ADDENDUM NUMBER 3

MARCUS CENTER FOR THE
PERFORMING ARTS
HVAC RETROFIT PHASE 2 & 3
Site #270, Bldg. #50
929 North Water Street
Milwaukee, Wisconsin

Project Number: O038-09416-02

Date of Addendum: December 2, 2010

DRAWING SD-1

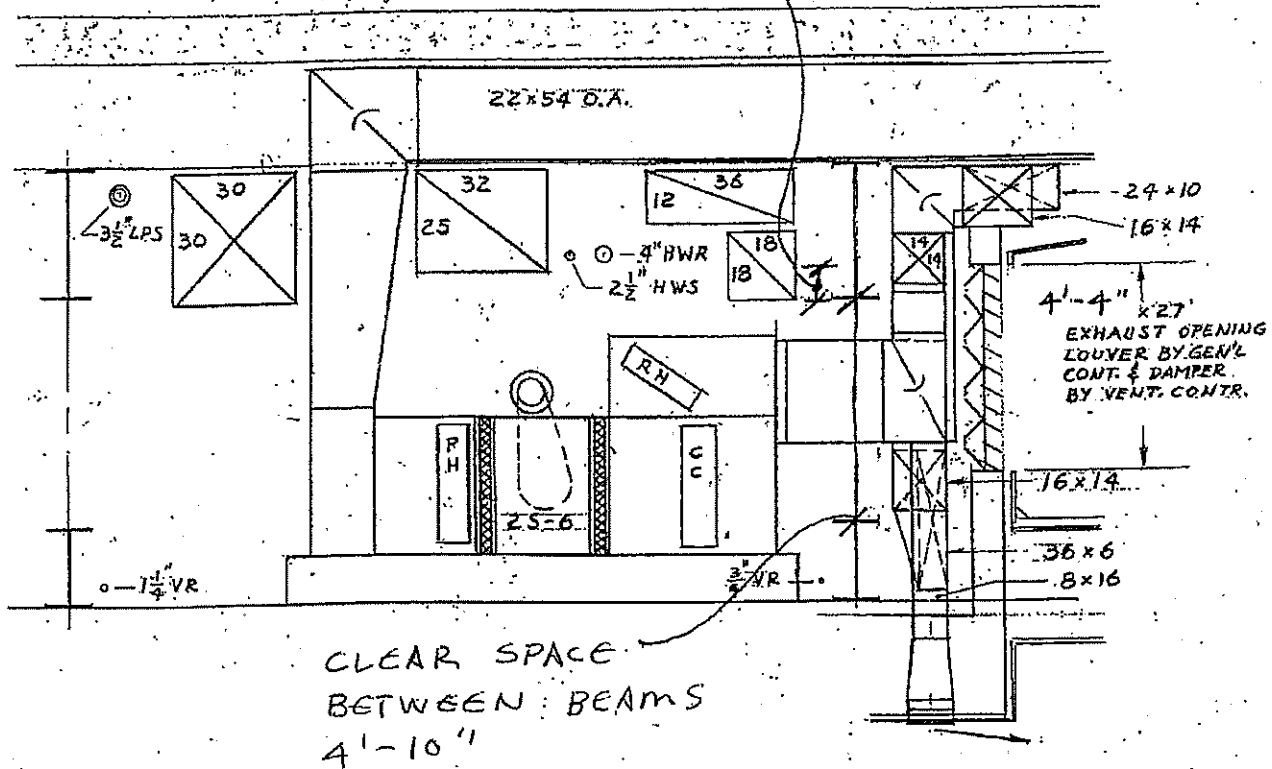
Supplemental Drawings: See the attached drawing (SD-1) for details regarding the available clearances at the relief louver serving Mechanical Room 515 and the structural steel members located just inside the mechanical room.

Clearance notes for supplemental drawing SD-1:

- Exhaust Louver opening was field measured to have 4'-4" clearance top to bottom.
- The structural steel beam located at the ceiling inside Mechanical Room 515 was field measured and cuts the clearance available straight through the exhaust louver by 6". Leaving approximately 3'-10" clear.
- The clear space available between the structural beam at the ceiling and the structural beam at the floor was field measured to be approximately 4'-10" clear.
- All air handling unit modules that will not fit through the clear space indicated above and shown on drawing SD-1 shall need to be dis-assembled and have the individual panels and other components moved through the louver opening individually.

BEAM AT CEILING
CUTS INTO LOUVER
CLEAR SPACE 6"

CLEAR SPACE
BETWEEN BEAMS
4'-10"
